CITY OF West Linn

STAFF REPORT FOR THE PLANNING COMMISSION

FILE NUMBER: DR-25-04/LLA-25-02 (Residential Component only)

REQUEST: The applicant is requesting approval of a Class II Design Review and Property Line Adjustments for the residential components of a mixed-use development at 2410/2422/2444 Tannler Drive and 1800 Blankenship Road. The proposal includes 320 multi-family residential units in 10 buildings, garages, clubhouse, accessory uses, and 11,630 sq. ft. of commercial space on ground floor of four buildings.

Figure 1: Excerpt of Site Plan – Left-turn movements from Tannler Drive into the driveway should be evaluated in conjunction with adjacent parking and backing maneuvers.

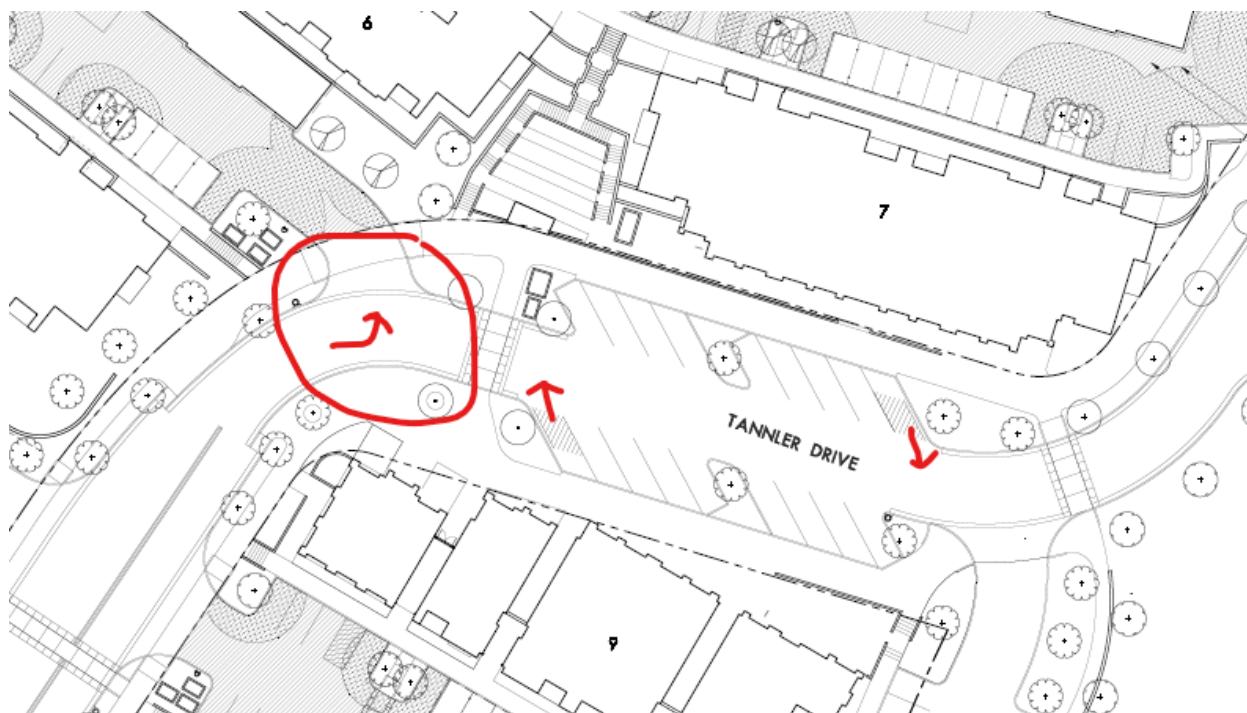
The proposed parking area is located between horizontal curves on Tannler Drive and is also affected by roadway grade changes. This combination of horizontal and vertical curvature may limit visibility for both drivers backing from parking spaces and motorists approaching the parking area. In addition, adjacent parked vehicles may further restrict sight lines. This creates the potential for approaching motorists to have limited opportunity to detect and react to vehicles entering the travel lane.

Similarly, drivers backing from angled parking spaces may have difficulty determining whether sufficient gaps exist in approaching traffic before beginning a maneuver. The ability to safely complete these movements depends on adequate visibility between the backing vehicle and approaching motorists, particularly given the constrained roadway geometry.

Given the combination of horizontal curvature, roadway grades, vehicle screening effects, and backing movements into a travel lane, additional analysis should be provided during the land use review process rather than addressed during permit review. If adequate visibility cannot be demonstrated, consideration should be given to alternative parking configurations, relocation of

Figure 3: Tannler Drive Improvements on north end of project illustrating multiuse path on west side of Tannler Drive.

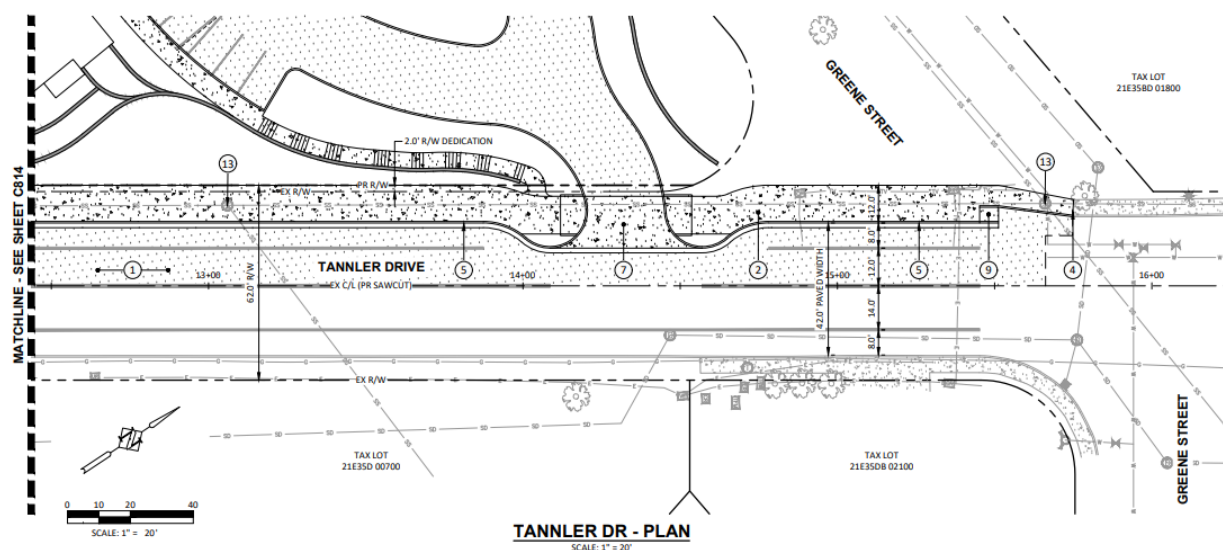
The proposed development includes a multi-use path along the north and east side of the proposed development along Tannler Drive intended to accommodate bicycle and pedestrian travel. However, the TIA does not provide a complete analysis of how users will safely transition between facilities or navigate crossings along Tannler Drive to the north of the site.

The applicant should be required to demonstrate how the proposed facility integrates with the existing bicycle and pedestrian facilities north of the project and how users are expected to transition between facilities in a safe and intuitive manner that will not result in wrong way travel or crossing Tannler Drive at unsafe locations.
